TECHNICAL REVIEW COMMITTEE (TRC) COMMENTS FORM

RE : ASTA Parking – 111 S. Ocean Dr. – Cond. Use with New Construction

TO : Kori Benton, Senior Planner
FROM : John R. Andrews, P.E., City Engineer
**RE : ASTA Parking – 111 South Ocean Drive
Conditional Use Application
TRC No. 17-0400005**

**SUBJECT: Variance & Conditional Use with New Construction
ASTA Parking
111 South Ocean Drive**

9) Pursuant to City Code Section 22-53. - Clear vision areas.

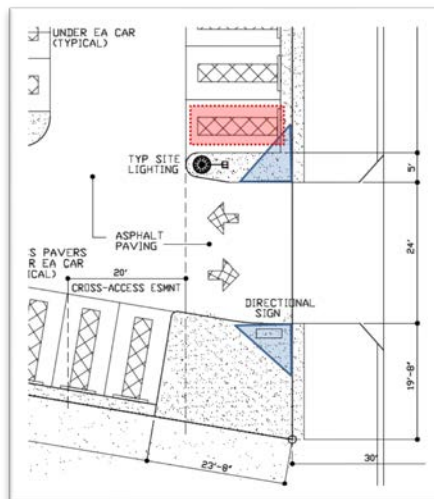
(a) A clear vision area shall be maintained on the corner of all property adjacent to the intersection of two (2) streets or of a street and a railroad, or **a street and a driveway**, except in a C-4 zone. A clear vision area shall contain **no planting, fence or temporary or permanent obstruction** exceeding twenty-four (24) inches in height measured from the top of the curb or, where no curb exists, from the established centerline grade, except that the following may be permitted:

(b) A clear vision area shall consist of a triangular area, two (2) sides of which are right-of-way lines or, in the case of an intersection of a street with a driveway, **the street right-of-way and the edge of the driveway**. The third side is a line across the corner of the property which connects the ends of the other two (2) sides. The size of the clear vision area is determined by the distance from the point of intersection of the two (2) right-of-way lines to the third side or, in the case of an intersection of a street with a driveway, the **Resolved - Redesign** of intersection of the right-of-way line with the driveway edge to the third side, measured along the right-of-way line(s) or driveway edge. This distance shall be twenty (20) feet where a street intersects with another street or a railroad. **The distance shall be ten (10) feet where a street intersects with a driveway.**

The southern space, on the east row of parking spaces, appears to infringe upon the required Clear Vision Area, which will require elimination, adjustment/clarification to the design, or pursuit of a variance. Furthermore, please ensure placement of trees and their associated canopy does not infringe upon required clear vision areas.
